RESPONSE TO SUBMISSIONS REPORT

The New Primary School in Mulgoa Rise - SSD-11070211

17 November 2021

DIAGRAM 2 - Overall Ground Floor Covered Structure Diagram – Proposed Development (NTS)

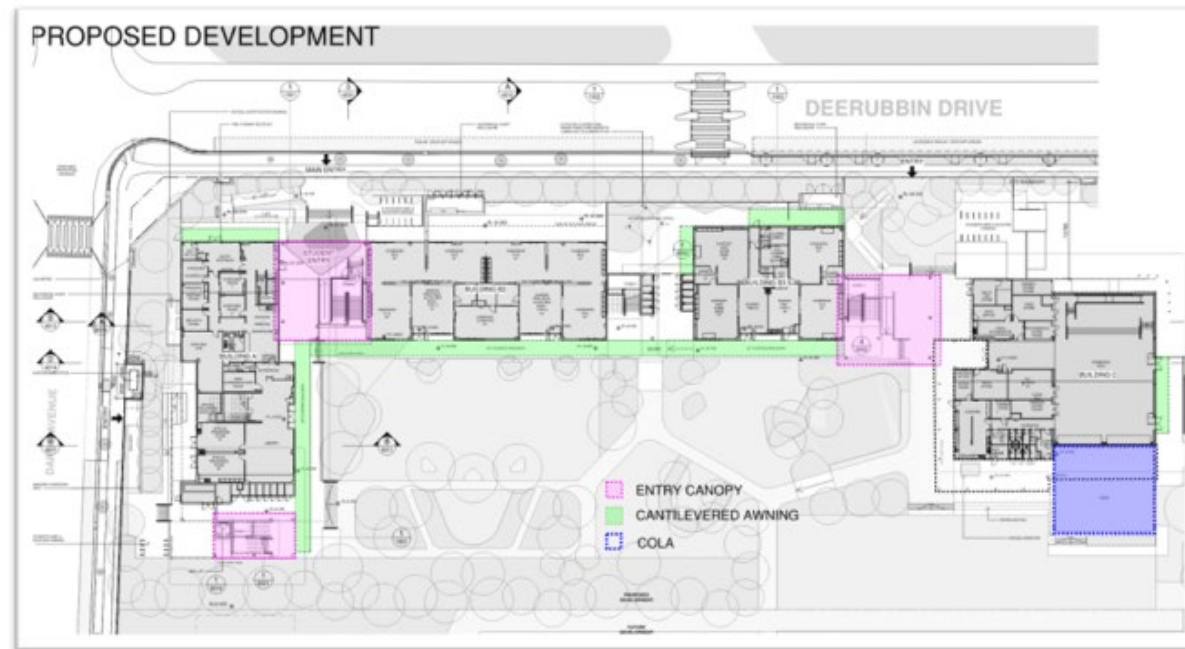
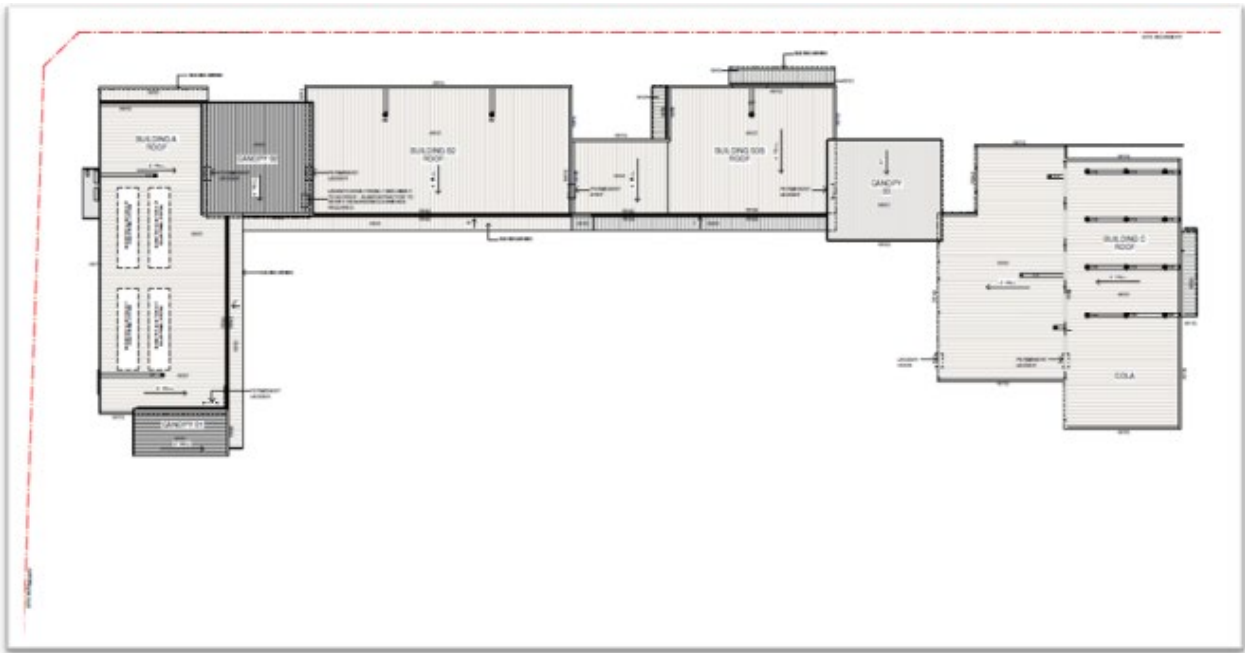
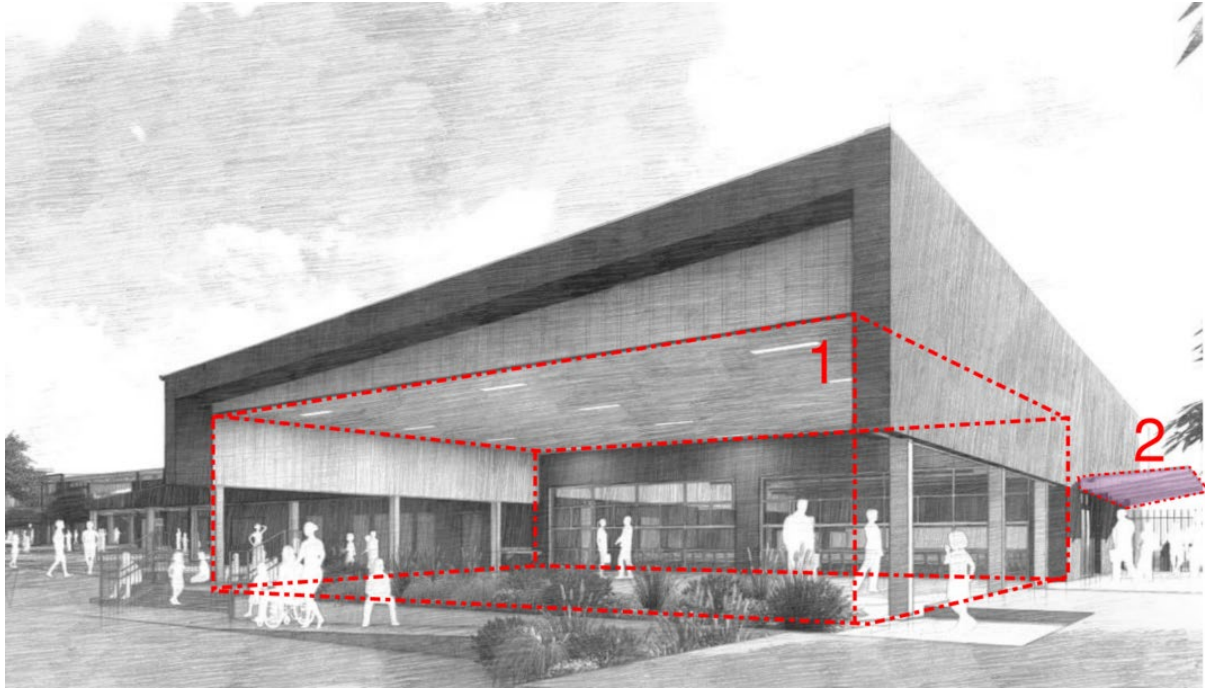
Proposed Action / Change	Reason for Action / Change
Architectural Design Changes	
Canopies – size, location & form The area highlighted in Diagram 1 and Diagram 2 in the adjacent column illustrates the extent of additions and reductions of roof area. Skylights have been removed. The lower canopy to the west of Block C Hall has been relocated to the southern side of Block C and is now identified as the COLA. Further discussion on the COLA is outlined below. The proposed revised roof plan is illustrated on page 10.	This design rationalisation provides structural design efficiency for a more economical solution while still maintaining the canopies as an identifying design feature at the pedestrian entries along Deerubbin Dr and Darug Ave. Skylights have been removed due to complexity of maintenance. Awning placements have been rationalised to prevent overlapping with high-level canopies.

Proposed Roof Plan (NTS)

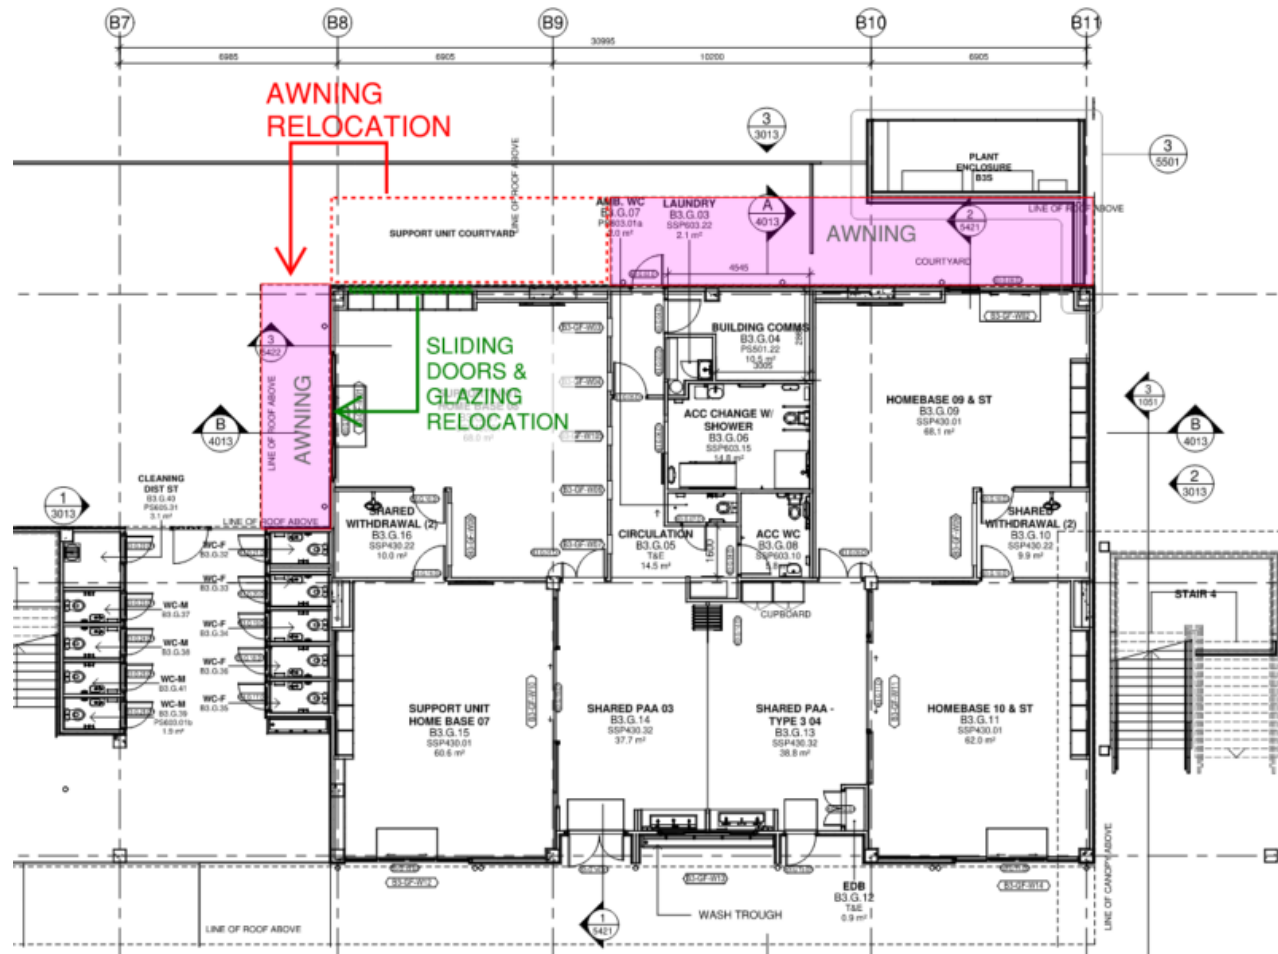
Proposed Action / Change	Reason for Action / Change
Relocation of the COLA and adjustments to Block C Hall Changes include: - The COLA has been relocated. - The doors on the eastern façade have been downsized and relocated with external cladding adjusted. - Block C roof - roof pitch is now proposed at 4° throughout. The changes are illustrated in the diagram in the adjacent column.	- The COLA has been relocated to the southern end of Block C, refer to Area 1 in the figure below, to better accommodate spill over from the hall during events and together with the tiered seating provide better connection to the future sports field. - The doors on the eastern façade have been downsized and relocated for egress purposes with a sheltering awning above – refer to Area 2 in the figure below. External cladding was adjusted to suit. Block C roof has been rationalised and roof pitch is now proposed at 4° throughout for better drainage.

Building B3 – Diagram to depict changes to Building B3 (NTS)

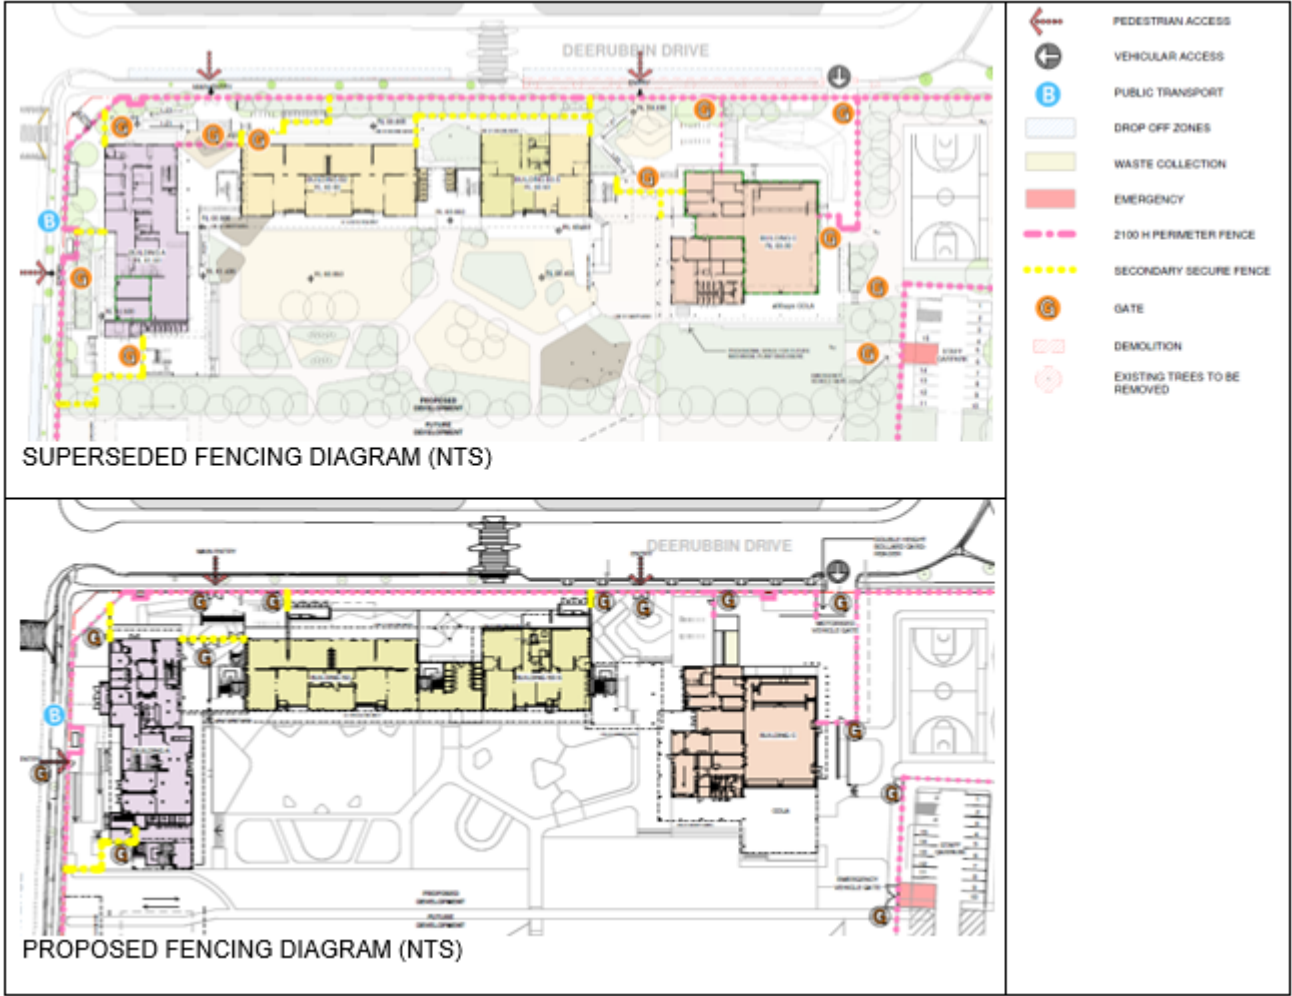
Updated layout and external awnings of Block B3S Changes include: - Minor adjustment to the North & West Elevation of Block B3S. - Change to glazed sliding door location.	The glazed sliding door connecting the support unit to the outdoor learning area has been relocated from the northern façade to the western façade including associated awnings above to align with the movement of the awning to the western side of Block 3. The location of Stair 3 and student amenities between Block B2 and Block B3S have been swapped to achieve better circulation between Level 1 and the play area. These changes have subsequently required minor adjustment to the North and West Elevation of Block B3S.

- The location of Stair 3 and student amenities between Block B2 and Block B3S have been swapped.

Proposed fencing section diagram (NTS)

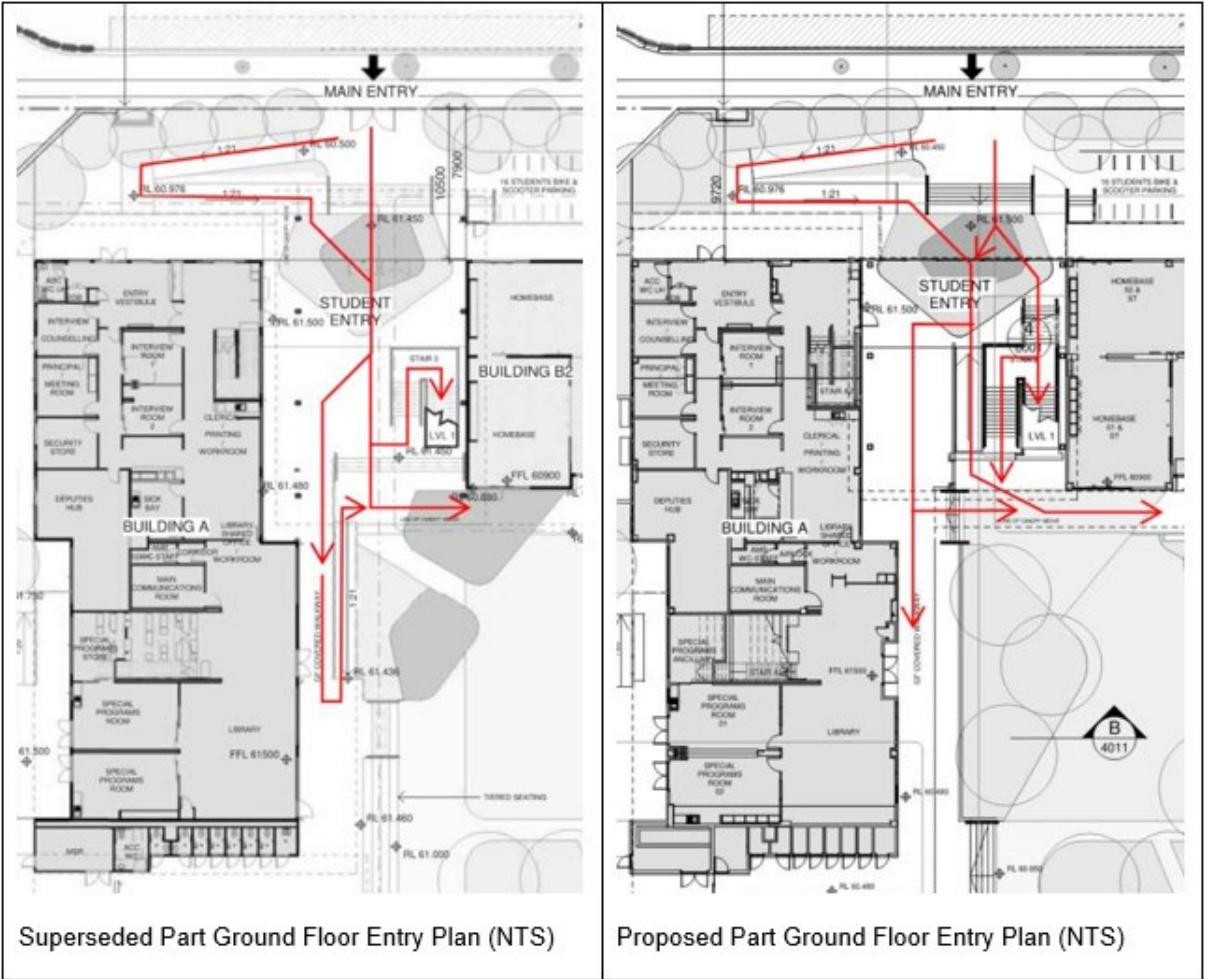
Security and fencing
Elimination of secondary fencing. The changes are illustrated in the diagrams in the adjacent column.

Further design development of the outdoor learning area between home base blocks B2 and B3S resulted with the elimination of much of the secondary security fence parallel to the boundary. Level changes in these areas will be managed via balustrades.

Relocation of services plant spaces

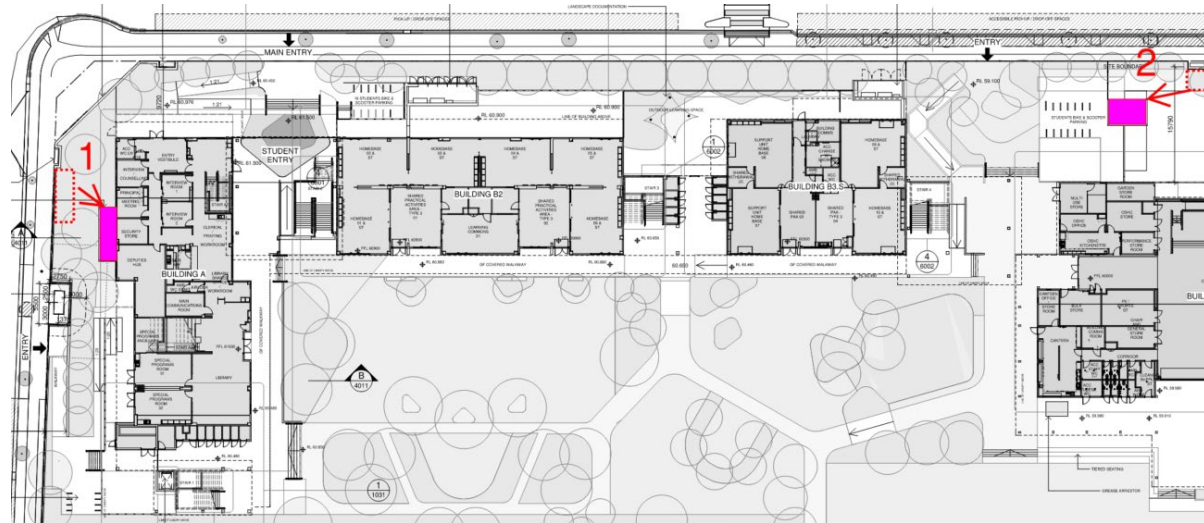
- Change 1 - The mechanical plant of Block A has been relocated from the site boundary on Darug Ave to sit adjacent to the building, on the western façade.
- Change 2 - The cold-water pump and fire hydrant pump have been set back from the boundary of Deerubbin Drive, closer to Block C.

Relocation of the mechanical plant was to facilitate better services reticulation. All windows located immediately adjacent to and directly above the plant will be upgraded to using thicker laminated glass for better acoustic attenuation.
Relocation of the cold-water pump is to allow more intensive landscape along the street frontage.

Proposed External Finishes Selection

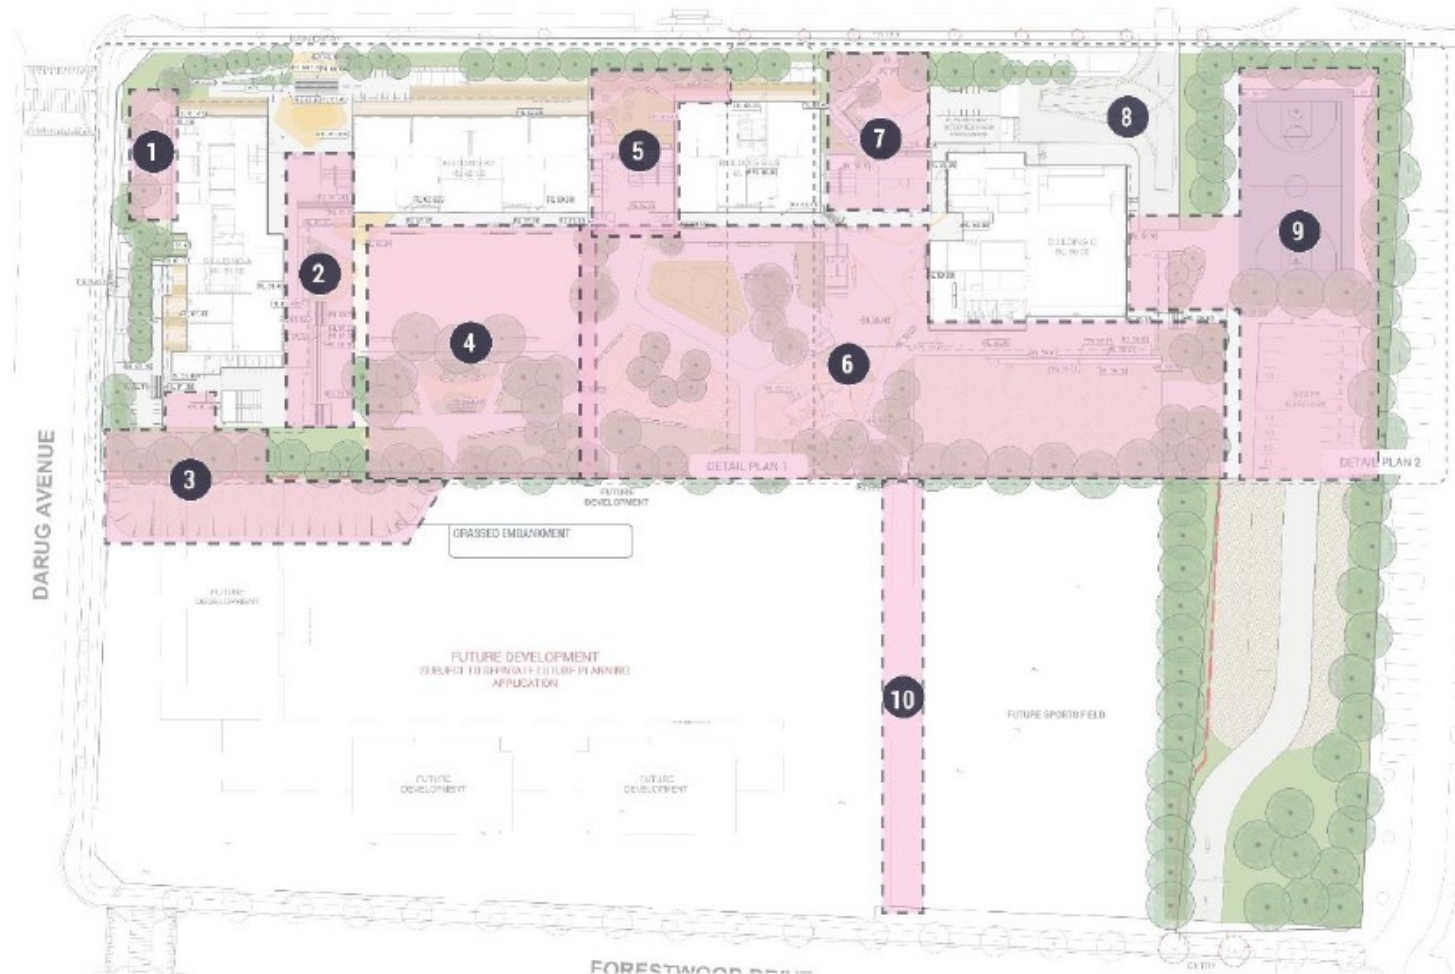
- Replacement of plywood soffit panels with pre-finished metal sheets.
- Replacement of metal cladding along walkways with Prefinished CFC.
- Change of specification for the external metal cladding on Level 1 facing Deerubbin Drive and Darug Ave, from a flat metal cladding to ribbed metal panel cladding.

Figure 6 – Proposed Pedestrian Crossing at Darug Avenue, CSD and Signposting

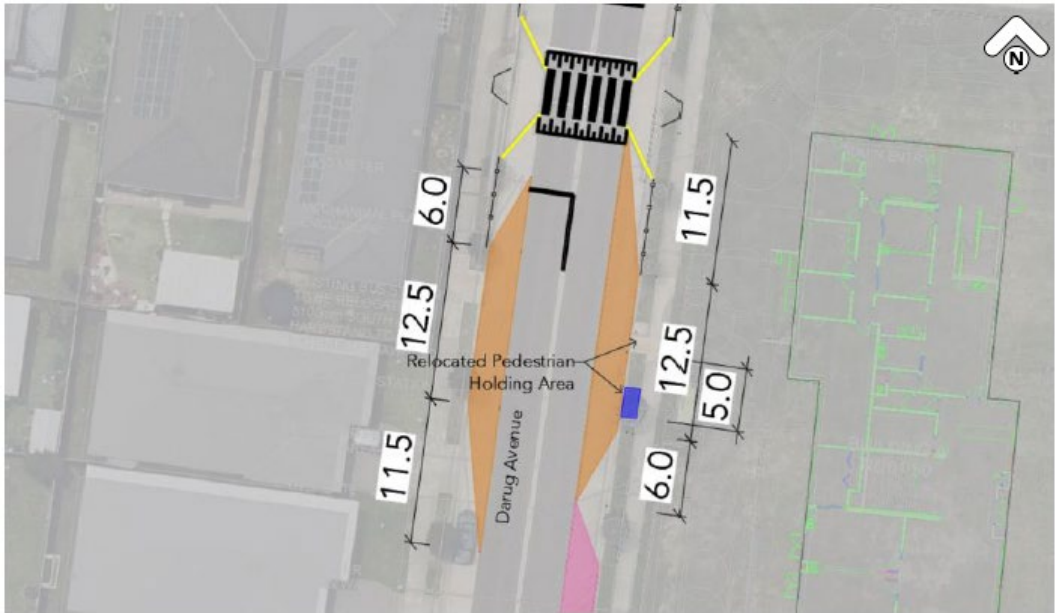
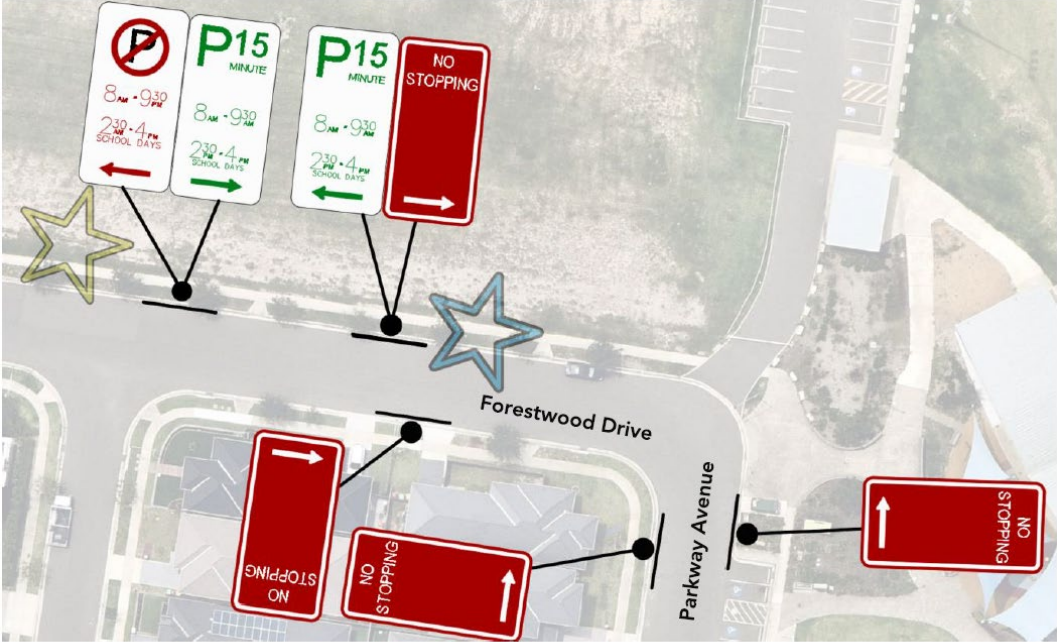
The proposed sight lines and 'No Stopping' sign for Darug Avenue are presented in Figure 6. The blue arrow represents the 97 m long CSD. The green line represents the sight line between the vehicle and the pedestrian approaching the zebra crossing. Due to the 2.5m wide "kerb extension", a pedestrian would stand at the edge of the traffic lane before s/he crosses the road and therefore be always visible to an approaching vehicle.

Comment/Issue	Response
	Based on the TDT 2002/12c and TDT 2011/01a, the 'No Stopping Sign' would be located at a distance of 7.5m from the zebra crossing where the kerb extension is ≥ 2.5m. Hence, the proposed 'No Stopping' signs at the proposed zebra crossings on Darug Avenue, Deerubbin Drive and Forestwood Drive meet the minimum requirement. The 'No Stopping' sign on the western side of Darug Avenue is proposed at 11m from zebra crossing as shown in to coincide with the "Bus Zone" sign. The Children Crossing sign is provided at 6m from the zebra crossing as per the TDT 2002/12c.
